Before the
FEDERAL COMMUNICATIONS COMMISSION

MM Docket No. 94-64
RM-8453

JOINT REPLY COMMENTS

**JOINT REPLY TO
NM DOCKET 94-64 - IDER, AL / LOOKOUT MTN, GA
ALLOTMENT OF FM CHANNEL 254A**

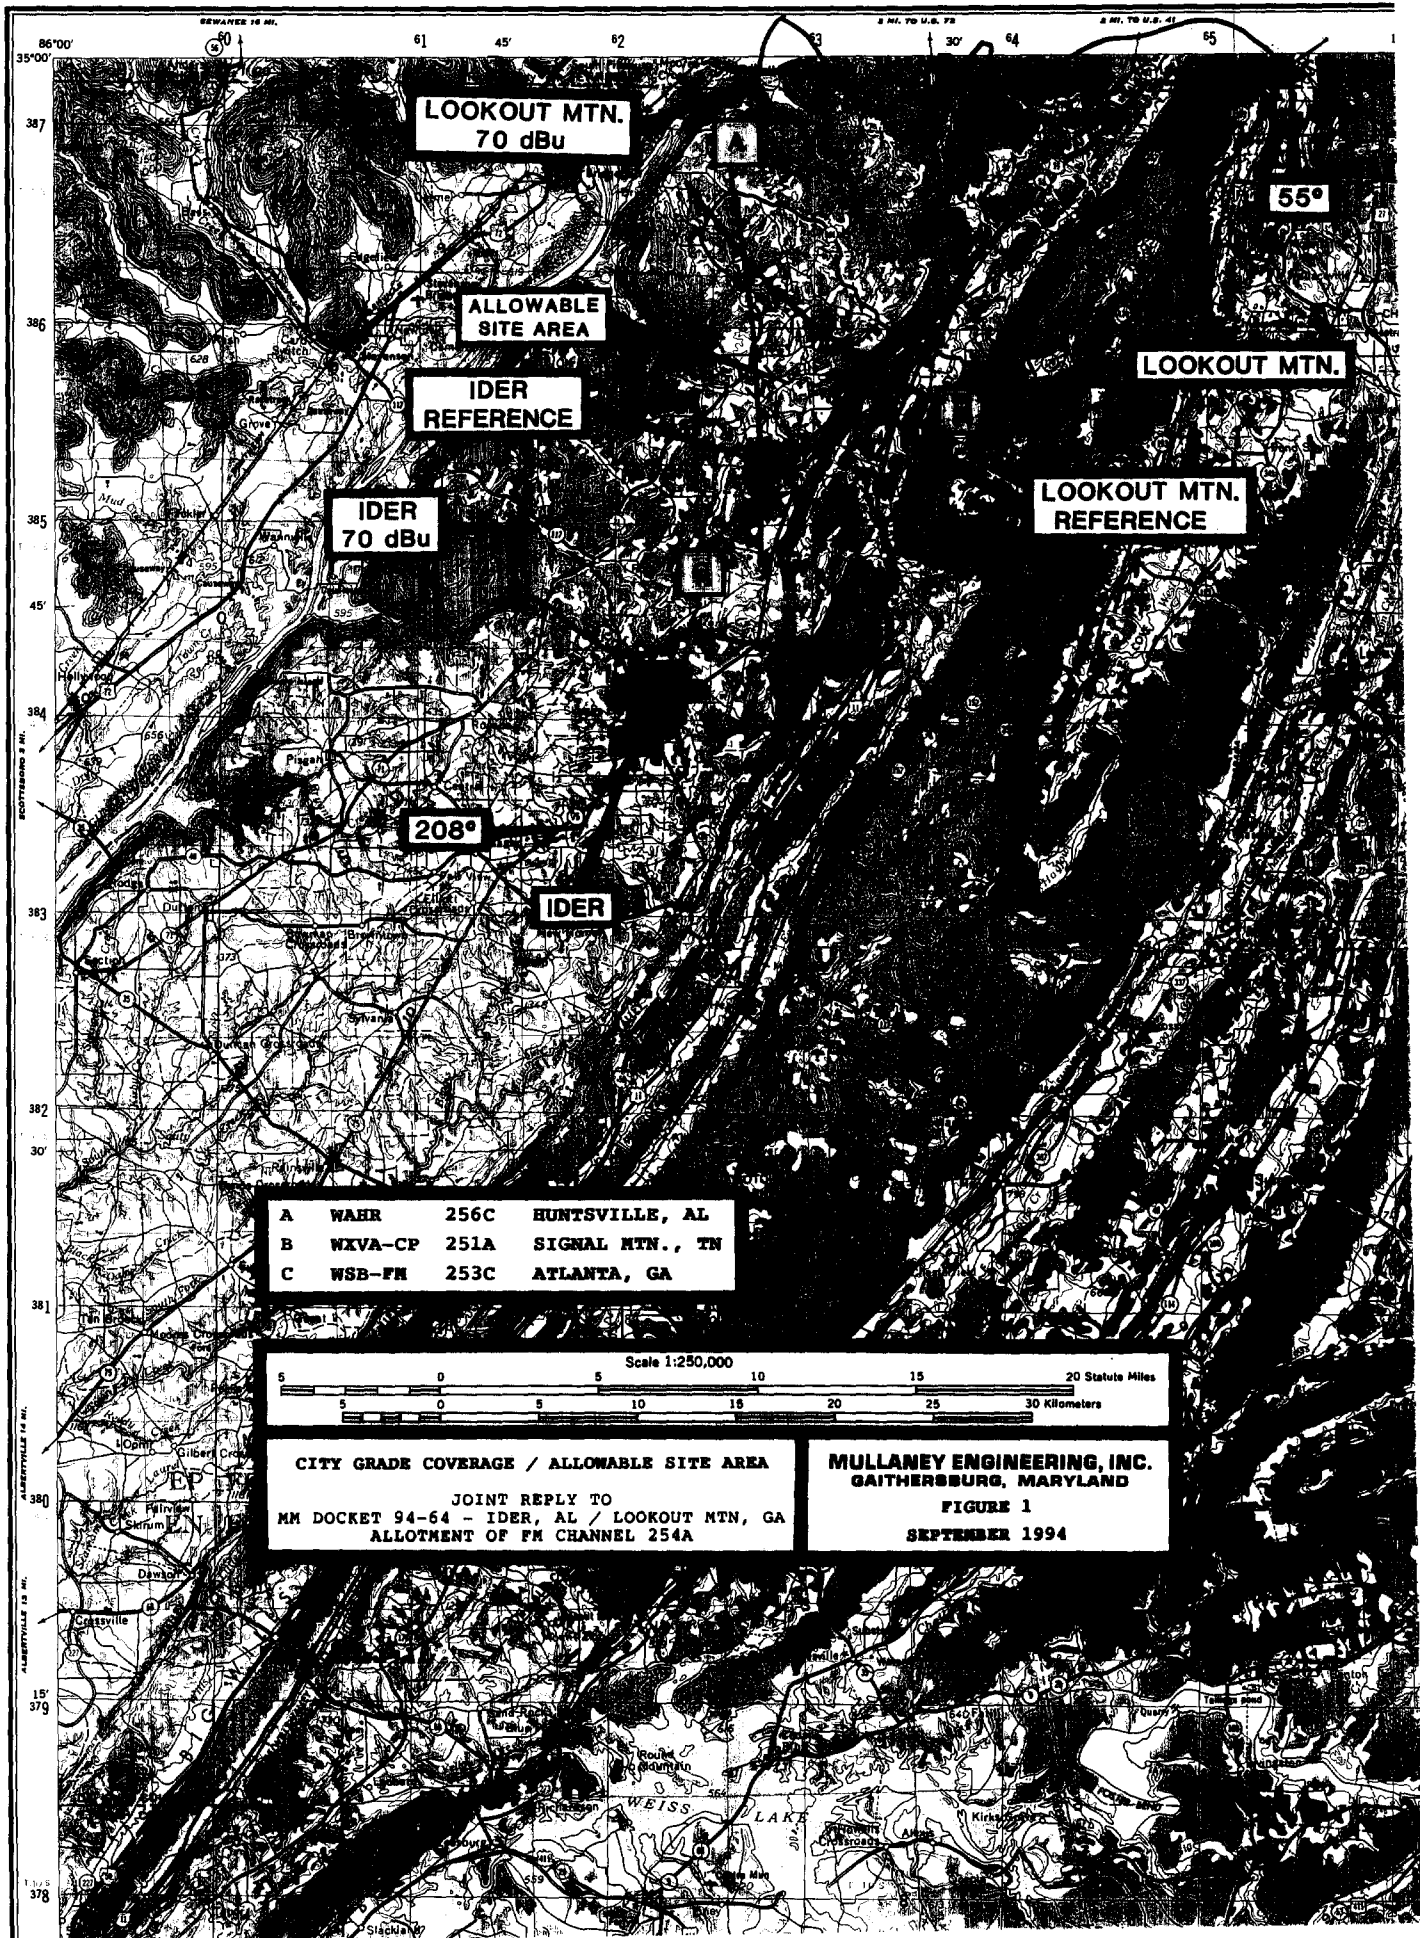
Figure 1 & 1-A are a map and tabulation of the predicted F(50,50) city grade 70 dBu contour from the special reference point for Ider, AL, assuming maximum Class A facilities. As can be seen, the proposed allotment fails to serve any portion of Ider, AL. It should be understood that, unlike the application process, rule making proceedings requires 70 dBu service to 100 percent of the city of license.

Figure 1 also illustrates the required separation from other existing FM stations that constrain the allowable area which complies with the separation

requirements contained in Section 73.207. The proposed special reference point is essentially as close to Ider as permitted under the rules. Consequently, selection of an alternate site will not cure this fatal defect of lack of city grade coverage.

Figure 1 & 1-B are a map and tabulation of the predicted F(50,50) city grade 70 dBu contour from the special reference point for Lookout Mountain, GA, assuming maximum Class A facilities. As can be seen, the proposed allotment appears at first blush to serve 100 percent of Lookout Mountain, GA.

Figure 1 also illustrates the required separation from other existing FM stations that constrain the allowable area which complies with the separation requirements contained in Section 73.207. The proposed special reference point is essentially as close to Lookout Mountain as permitted under the rules. Consequently, selection of an alternate site will not cure this fatal defect of lack of line of sight to the city of license.

N-55-E TERRAIN PLOT - LOOKOUT MOUNTAIN, GA

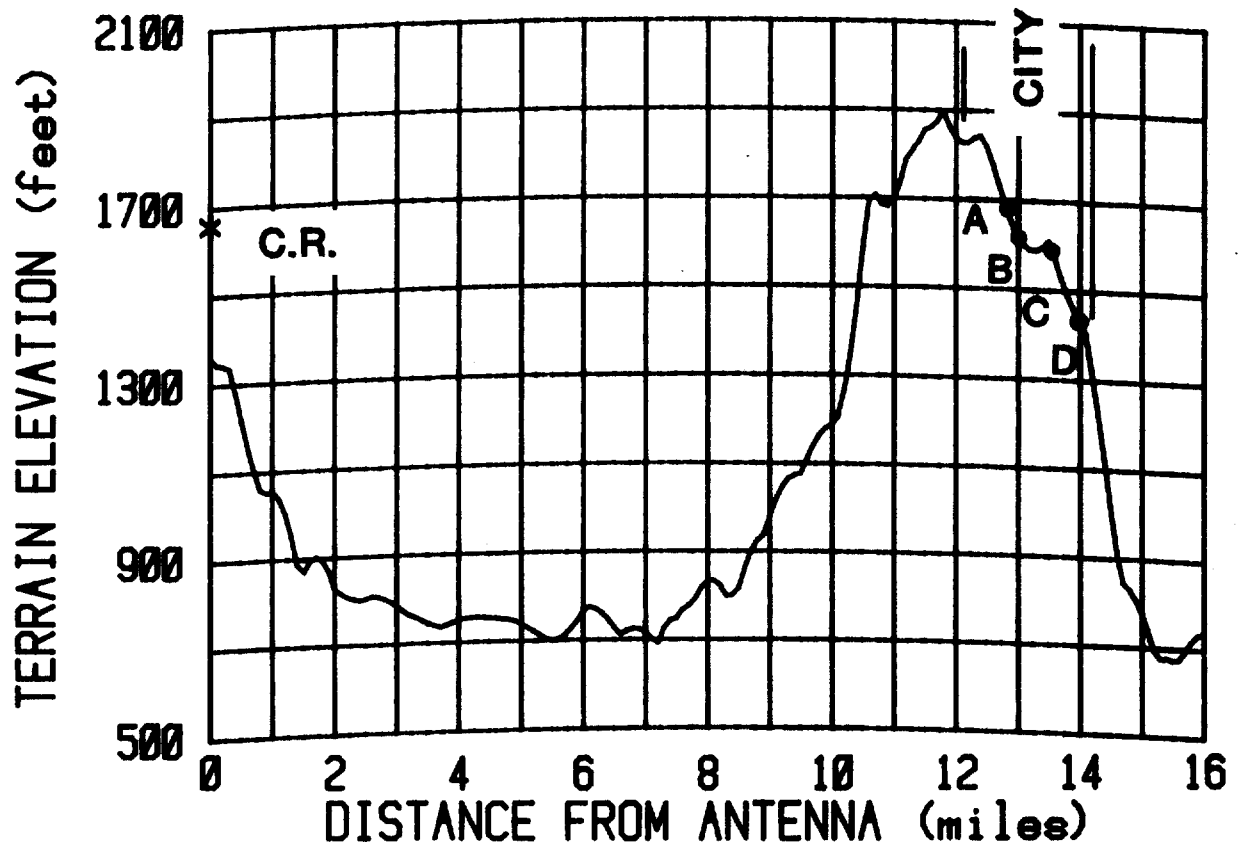
However, as illustrated by Figure 2, the intervening terrain along N-55-E does not permit one to establish line of sight to the city of Lookout Mountain. Section 73.315(b) - FM transmitter location - states the following:

The "C.R." on the left side of the plot represents a center of radiation that is required to achieve the maximum permissible HAAT of 100 meters. This represents a height that is 90.2 meters or 296 feet AGL. In order to establish something close to complete line of sight it would be necessary to propose an antenna center of radiation which is 609.6 meters or 2000 feet AGL. While not only being cost prohibited for a Class A facility it would also call into question the ability to obtain FAA approval for such a tall tower. Not to mention, environmental concerns.

The distance from the proposed special reference point to the city of Lookout Mountain, GA, varies from 19 to 24 kilometers (12 to 15 miles). Under normal allotment assumptions a Class A 6 kW facility places a city grade 70 dBu contour 16.1 kilometers (10 miles) away. Consequently, the theoretical F(50,50) coverage provided to Lookout Mountain was only possible due to the significant swings in terrain averages which provided a bulge of 9.5 kilometers over normal assumptions (257 m HAAT towards city).
